Memorandum

Subject: Clarification of Order 8260.3B, United States Standard for Terminal Instrument Procedures (TERPS), Paragraph 1750d

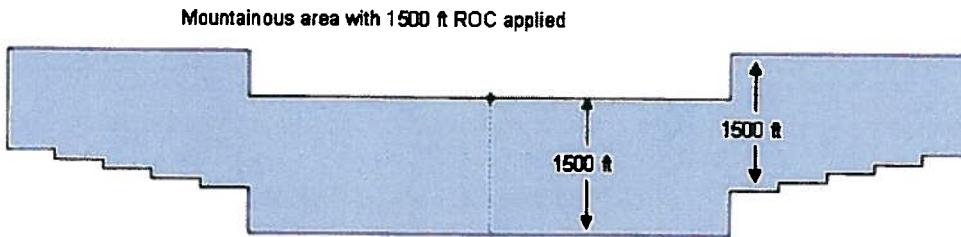
Paragraph 1750d.(2)(c) is sufficient for the above application where 2000 ft of ROC is applied to the primary area over mountainous terrain. However, it's inadequate when ROC has been reduced to 1700 ft or 1500 ft since the requirement as written would still require adding a full 1000 ft to the basic secondary clearance. The following figure illustrates this problem when 1500 ft of ROC has been applied in the primary area.

Without any provision to reduce the addition of 1000 ft in the secondary area, the resultant MOCA could be as much as 500 ft greater than required. On the other hand, the criteria for VOR airways do contain provisions to reduce secondary ROC over mountainous terrain when the primary ROC has been reduced to less than 2000 ft:

Conclusion. The intent of the current criteria is to apply an additional 1000 ft of secondary obstacle clearance only when the primary obstacle clearance is 2000 ft.

When primary obstacle clearance in mountainous areas has been reduced to 1700 ft, add 700 ft to the values specified in paragraphs 1750.d.(2) (a) and (b). When primary obstacle clearance in mountainous areas has been reduced to 1500 ft, add 500 ft to the values specified in paragraphs 1750.d.(2) (a) and (b).
